## MADDOX PLACE SUBDIVISION

The plat illustrates the proposed 71 lot,  $20.0 \pm$  acre subdivision which is located on the West side of McFarland Road, 290 feet  $\pm$  South of Hamilton Creek Drive. The subdivision is served by both public water and sanitary sewer.

The purpose of the subdivision is to create 71 lots and two common areas from one parcel.

## **DETAIL SITE PLAN**

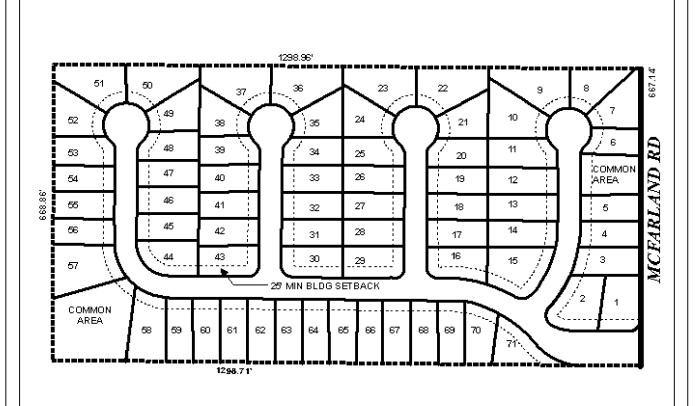
The site fronts McFarland Road, a minor street with a 60-foot right-of-way. Even though McFarland Road is a minor street, access management is a concern. A note should be placed on the plat stating that all lots and common areas fronting McFarland Road are denied access to McFarland Road.

The site has property lines at an intersection corner. Section V.D.6. of the Subdivision Regulations requires that "property lines at street intersection corners shall be arcs having radii of at least 10 feet or shall be chords of such arcs." The plat should be revised to reflect this requirement at the South side of the McFarland Road intersection.

There appear to be discrepancies in some of the lot line measurements, though it does appear that all lots meet minimum size requirements. However, the plat should be revised to ensure that all depicted bearings and measurements are correct. Furthermore, the lots should be labeled with their size in square feet, or a table should be provided depicting the same information.

Two common areas are depicted on the preliminary plat. It is also implied that an island will be provided at the entrance to the subdivision. All common areas should be depicted on the plat, and a note should be placed on the final plat, if approved, stating that maintenance of the common areas is the responsibility of the subdivision's property owners.

The 25-foot minimum building setback line, required in Section V.D.9., is depicted on the plat, but is not depicted for those lots with frontage onto McFarland Road. The plat should be revised to show the minimum building setback line from all streets.

1) placement of a note the plat stating that all lots and common areas fronting McFarland Road are denied access to McFarland Road; 2) revision of the plat to comply with Section V.D.6. of the Subdivision Regulations (property lines at street intersection corners shall be arcs having radii of at least 10 feet or shall be chords of such arcs) at the McFarland Road intersection; 3) depiction and labeling of all common areas; 4) placement of a note on the final plat stating that maintenance of the common areas is the responsibility of the subdivision's property owners; 5) depiction of the 25-foot minimum building setback line from all streets; 6) revision of the plat to correct any discrepancies regarding lot line measurements or bearings; 7) labeling of all lots with size in square feet, or placement of a table on the plat containing the lot size information; and 8) placement of a note on the final plat stating that any lots which are developed commercially and adjoin residentially developed property must provide a buffer, in compliance with Section V.A.7. of the Subdivision Regulations.
